Division of Reclamation,
Mining and Safety

RE: Boettcher Limestone Quarry, Permit No. M-1977-348, Technical Revision No. 10 (TR-10), Adequacy Review No. 1

M-1977-348 / Boettcher Limestone Quarry / Holcim (US) Inc.

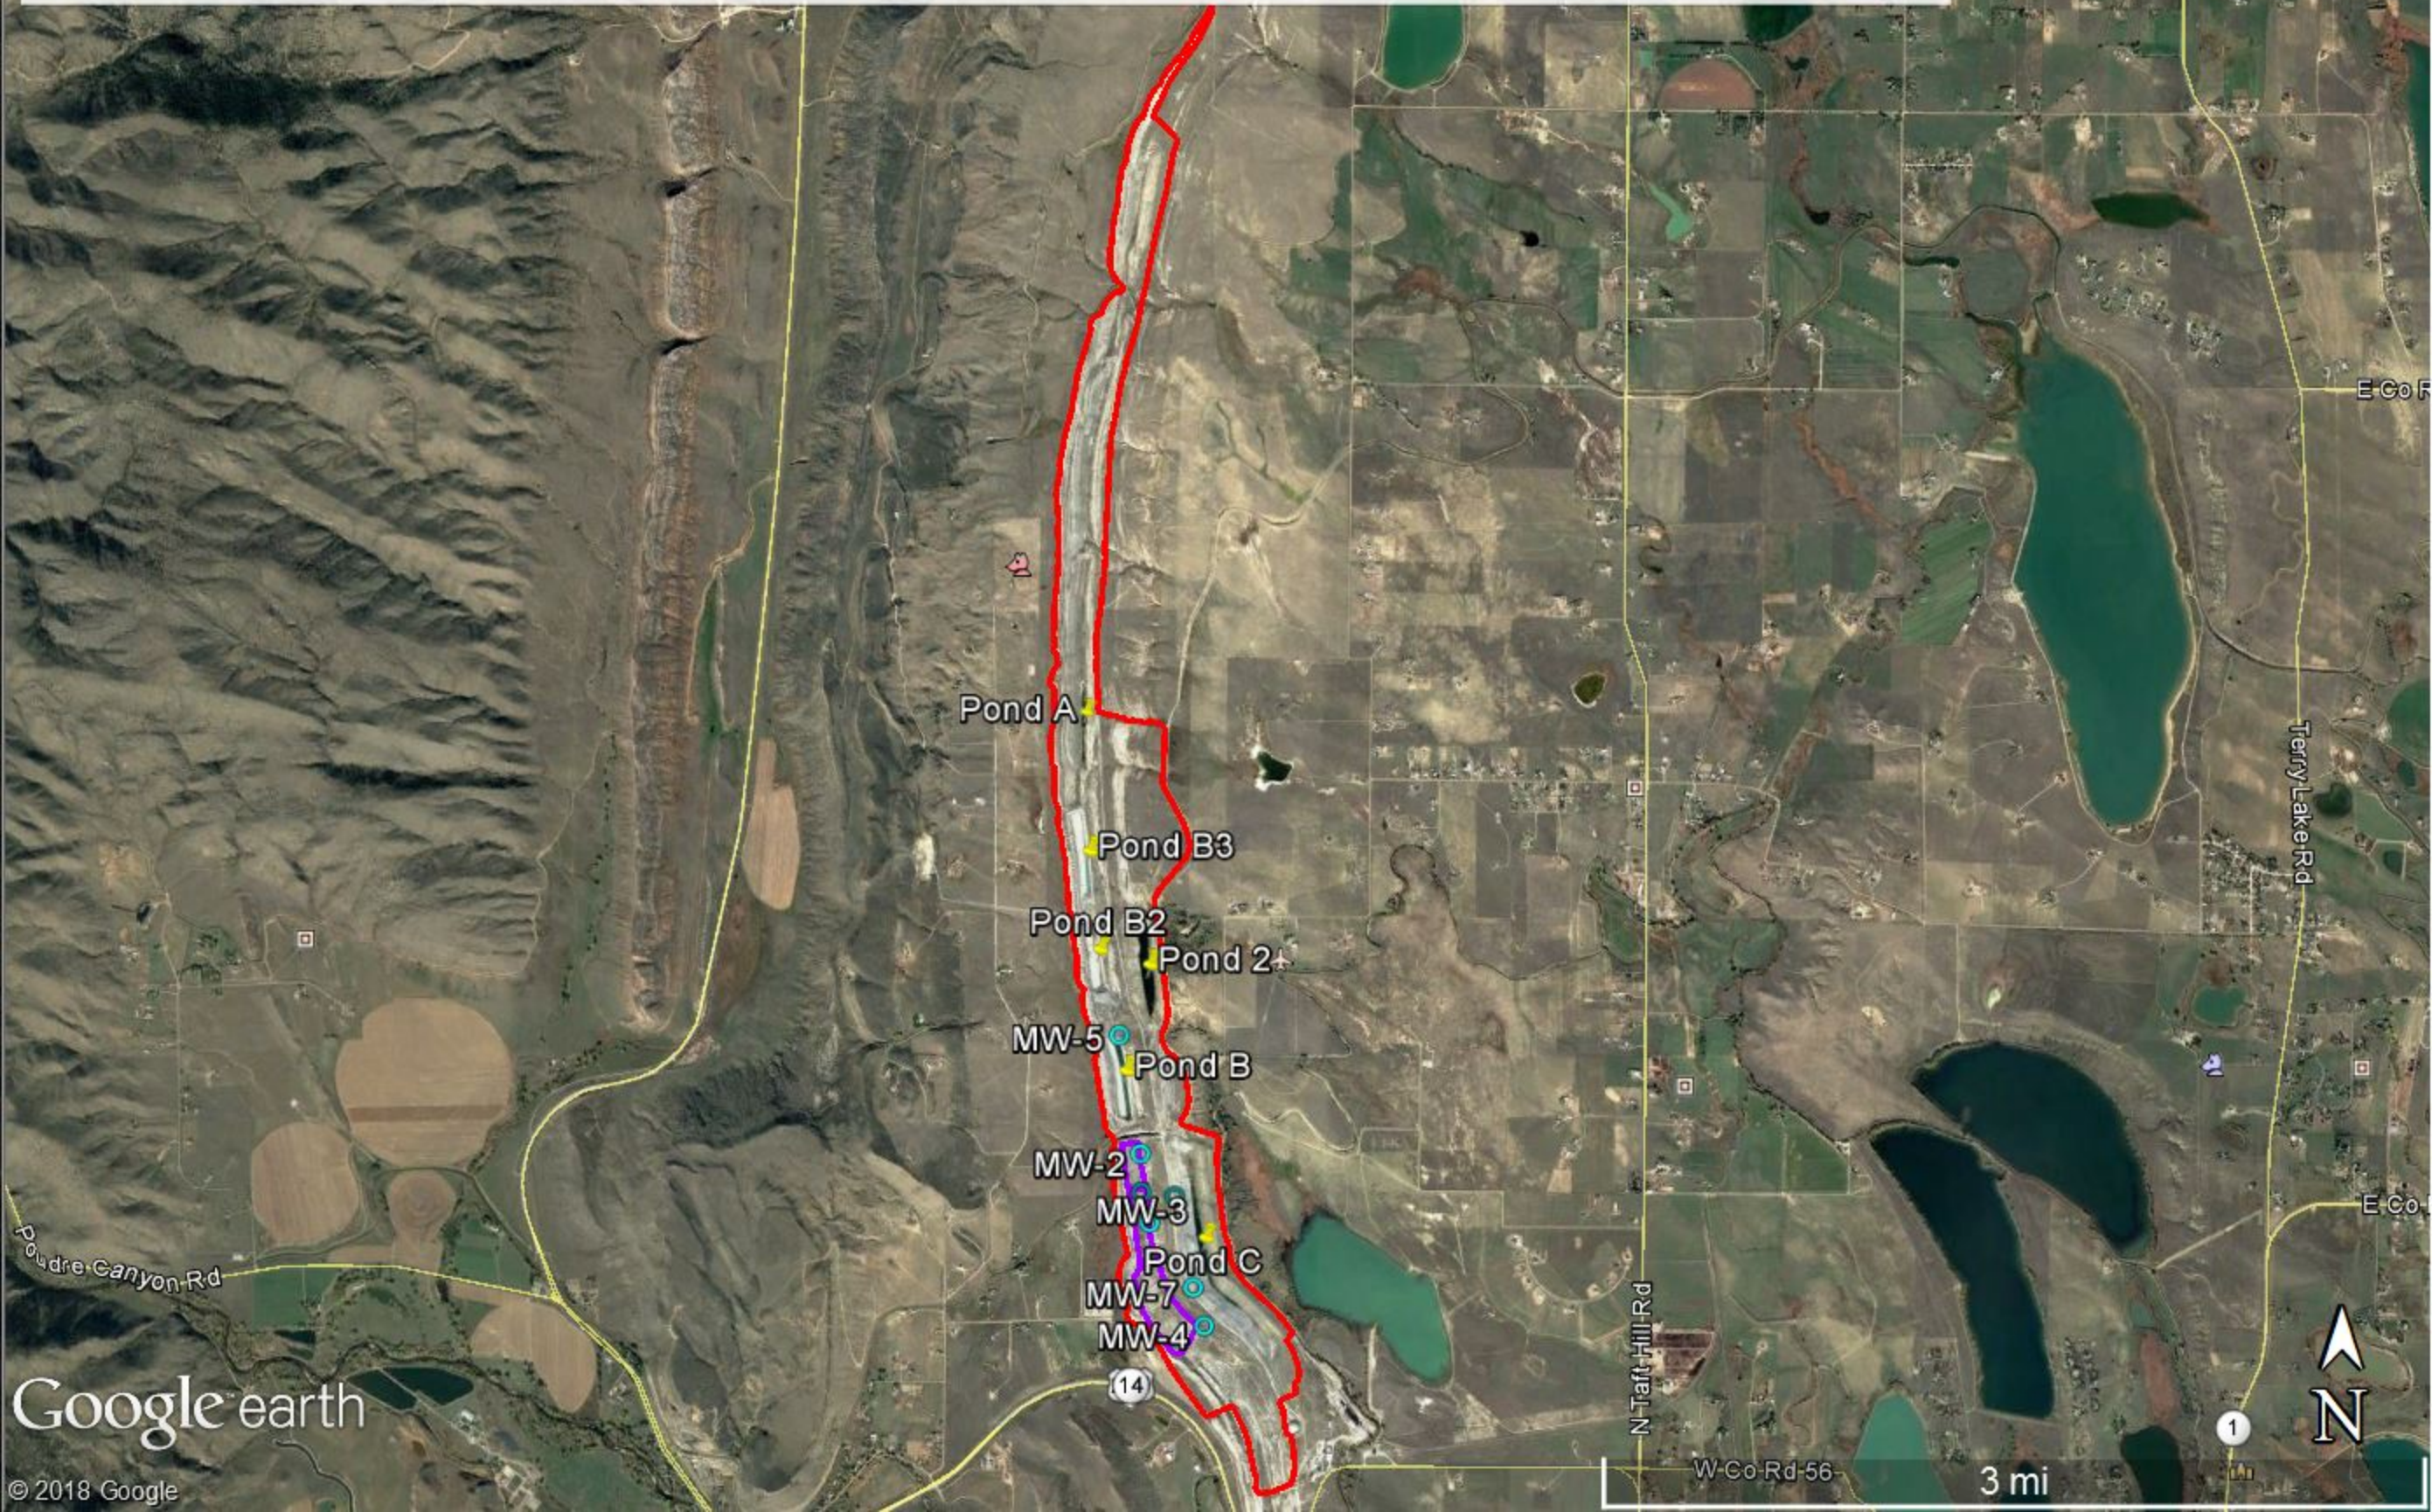
- 11) The amended permit boundary as shown on Figures 1, 4, and 11 appears to be incorrect. On these figures, the CKD disposal boundaries overlap the western permit boundary. The Division believes this is an error, as the permit area should encompass the CKD disposal areas (see enclosed Google Earth images of site showing approximate location of approved permit boundary). Please correct the location of the permit boundary and/or CKD disposal areas as portrayed on all relevant figures.
